IMPROVEMENTS ON THE
 OCEAN CLEANUP SYSTEM
 BY ERIK VAN VLIET
 0630264550

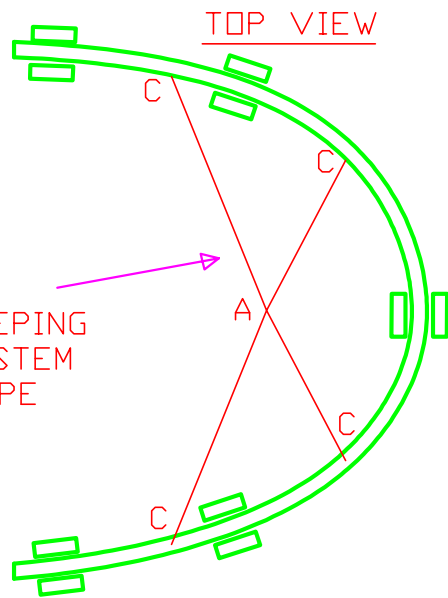
CABLES FOR KEEPING
 THE PACMAN SYSTEM
 IN RIGHT U SHAPE

SIDE VIEW

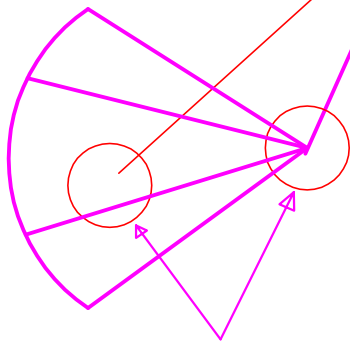
STRAIGHT ANCHOR LINE
 GIVES HIGH LOADS ON
 FLOATING SYSTEM

ROTATION OF MAIN
 TUBE DUE TO SIDE
 BUOYANCY FLOATERS

BUOYANCY
 ADDED

BUOYANCY
 ADDED

WEIGHT
 ADDED

RETRACTABLE
 PARACHUTE ADDED
 FOR RIGHT VELOCITY

FLOATING ANCHOR
 IN THE DEEP

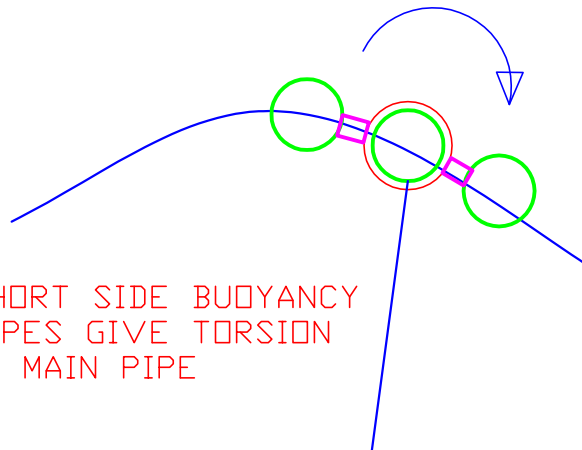
SHORT SIDE BUOYANCY
 PIPES GIVE TORSION
 IN MAIN PIPE

PLASTIC FOIL HANGING
 IN WATER

LET SIDE FLOATERS
 ROTATE MORE EASY
 AROUND MAIN PIPE
 USE ELASTIC ROPES
 FOR CONNECTION
